UNITED STATES PATENT AND TRADEMARK OFFICE

APPLICATION NO.	FILING DATE	FIRST NAMED INVENTOR	ATTORNEY DOCKET NO.	CONFIRMATION NO.
10/061,861	02/01/2002	R. Brad Campbell	PM 2000.097	2381

Office Action Summary

DETAILED ACTION

Attachment: Fig. 3 of Davies et al. (US 5,758,990)

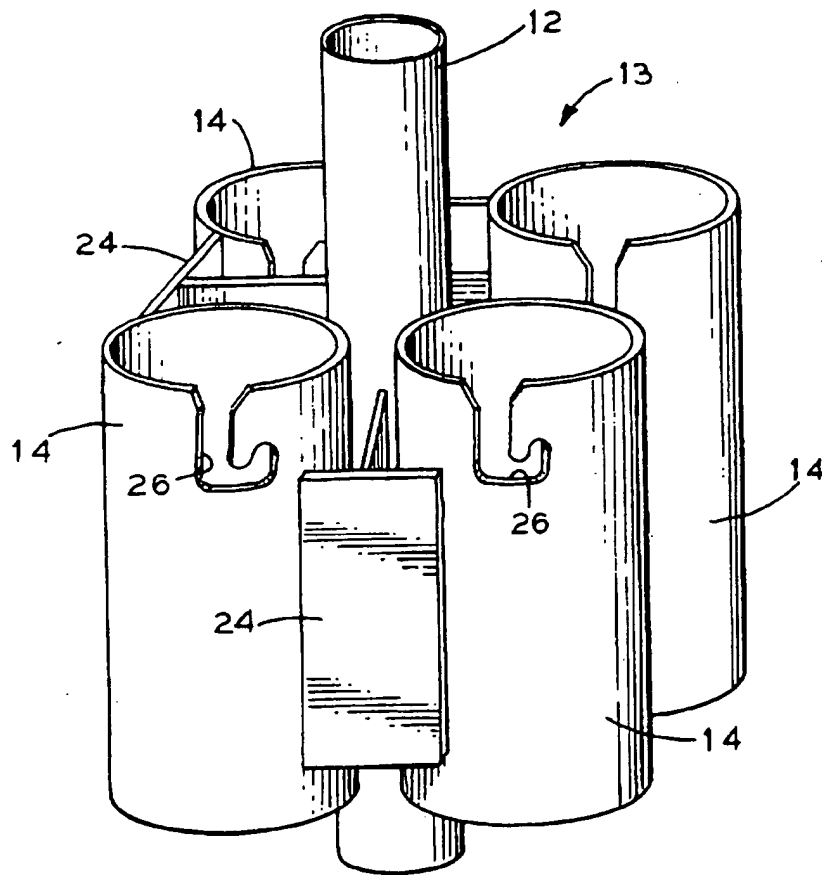
Davies et al discloses a riser tensioning device comprising of: at least one buoyancy element/buoyancy can (16); a frame/yoke/guide frame (24, 54) comprising a plurality of vertical tubular members (14) externally disposed to a plurality of buoyancy elements (22) by enclosing the buoyancy elements and the frame/yoke comprising a plurality of connectors (24) securing the vertical members to a riser stem pipe (12), the riser stem pipe secured to a riser (18), the one or more connectors (24) having a radial arms (A) (see Fig. 3) with a plate, the frame further comprising at least one horizontal bracing member (B) external to the buoyancy member (16); one or more gas service lines (36) positioned within the frame and enter the buoyancy can (16) and the frame/yoke with guide frame extending the vertical length of the at least one buoyancy

Although Davies et al fails to specifically disclose the vertical members continuously extending the vertical length of the at least one buoyancy element, it would have been obvious to one of the ordinary skill in the art at the time the invention was made to extend the vertical member's length to the vertical length of the buoyancy member in order to protect the whole length of the buoyancy member.

Further, with respect to the frame's structural function of carrying loads exerted by external force, such as wave and/or current action in the water, it is believed to be inherent that Davies et al's frame protect the riser from external loads of wave or current action in the water while being in use.

10. Applicant's arguments with respect that Davies et al reference does not disclose the vertical members, which are positioned intermittently, spaced and continuously to extend the vertical length of the buoyancy element is not persuasive because it would have been obvious to one of ordinary skill in the art at the time the invention was made to merely provide the continuous vertical member in order to cover the whole length of the buoyancy element.
